East Anglia THREE
Offshore Windfarm

Applicant's Response to Action Points and Rule 17 Letter

Document Reference – Deadline 6/Action Points
and Rule 17 Response

ISH 24th October – Environmental Matters

Figure 1

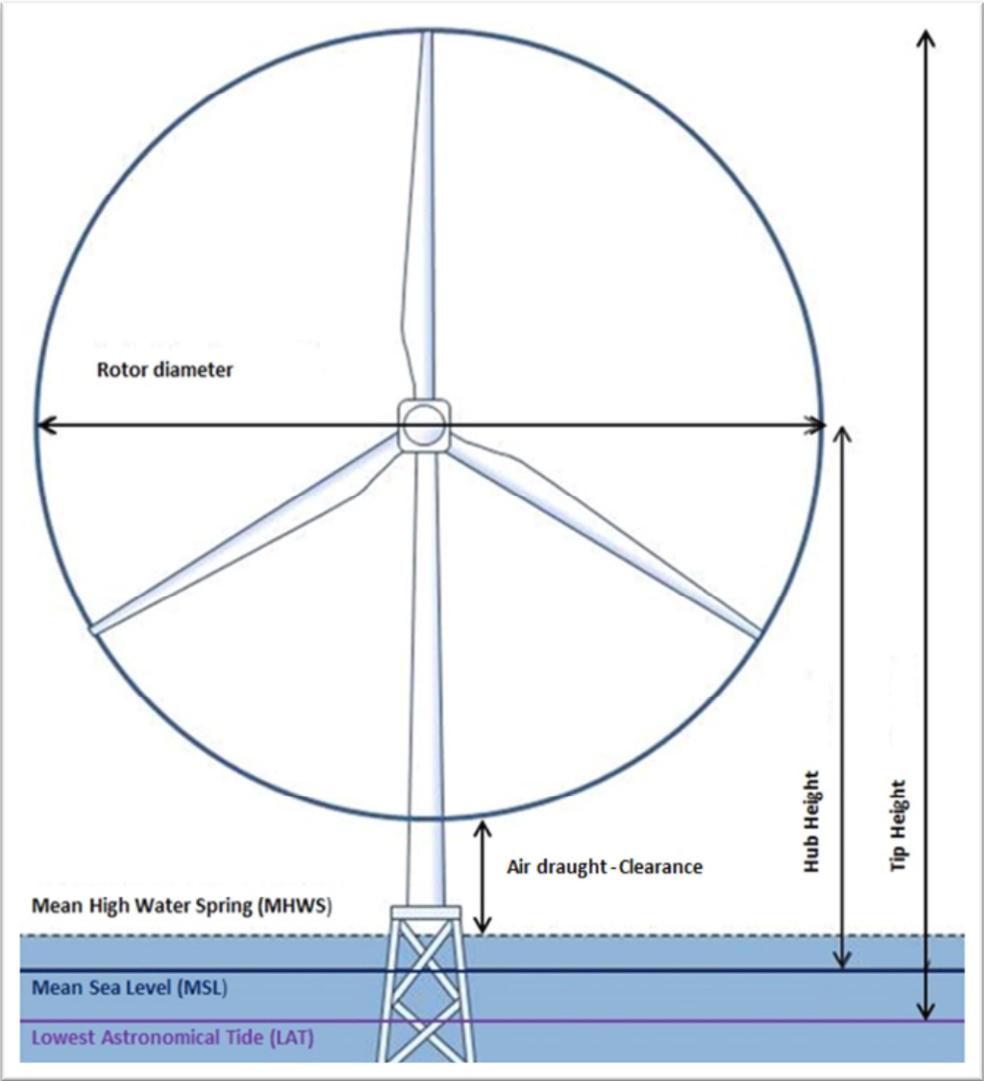
2	Applicant to provide update on Contract for Difference (CfD) process and how this provides comfort regarding the number of turbines to be built at the East Anglia ONE offshore wind farm (EA1).	The Applicant

Applicants response	<p>The East Anglia One project secured a contract for difference (CfD) for 714MW through the first CfD allocation round in February 2015. Under the terms of the CfD there is no ability to increase the size of the project, only ability to reduce capacity in certain circumstances. Given the restrictions in changes to capacity under the terms of the CfD, under the CfD awarded the EAONE project can only deliver a maximum capacity of 714MW.</p>	
3	<p>Applicant to provide further details, including a plan if necessary, of how the proposed change to draught height has been calculated.</p>	The Applicant
Applicants response	<p>The East Anglia THREE draught height was set at 22m Mean High Water Springs (MWHS) following Marine Guidance Note (MGN 372) for navigational clearance and taking the site conditions into consideration.</p> <p>The Applicant has been in discussion with RSPB in relation to their request to increase draught height for the purposes of reducing collision risk since the beginning of the Examination. Typically such decisions would not be made until post consent at a time when technical and commercial considerations are better understood. However, following a detailed review by internal and external specialists, and having considered the key technical and commercial risks and other relevant constraints, EATL has, at the preconstruction stage, commit to a 2m MHWS draught height increase from 22m to 24m across 70% of turbines. This commitment was positively received by RSPB.</p> <p>There will be no increase to the tip height parameters (up to 247m) set down in the draft Order as a result of this increase in draught height and there will be no spatial restriction on where the turbines with an increased draught height must be installed. The increase in draught height is proposed to be secured through amendments to the parameters in the DMLs (Sch 10 to 11) and also in the parameters contained in the Requirements of the draft Order.</p> <p>Figure 1 below illustrates various turbine height parameters with reference to ordnance datum, including draught height.</p>

Generally, offshore wind turbines are kept as low to the mean sea level as practically possible to limit the size of the foundations and correspondingly the size of fabrication facilities, transportation vessels and installation cranes. In practical terms, the minimum draught height requirement is driven by the need to keep the turbine rotors sufficiently clear of the foundation working platform to allow maintenance operations to be carried out safely; in particular the blades need to be above the reach of the platform maintenance crane. The platform height is in turn determined by the wave and tidal conditions at the site; the platform is positioned above the maximum wave crest elevation.

The Applicant took these factors into consideration in its discussions with RSPB when assessing the potential for an increase in draught height. Given the project variables outlined above and the early stage of the development in relation to ascertaining supply chain, and following an assessment of the reduction in collision risk associated with an increase in draught height, it was agreed that a 2m MHWS increase in draught height to 24m would be acceptable to the Applicant and the RSPB.
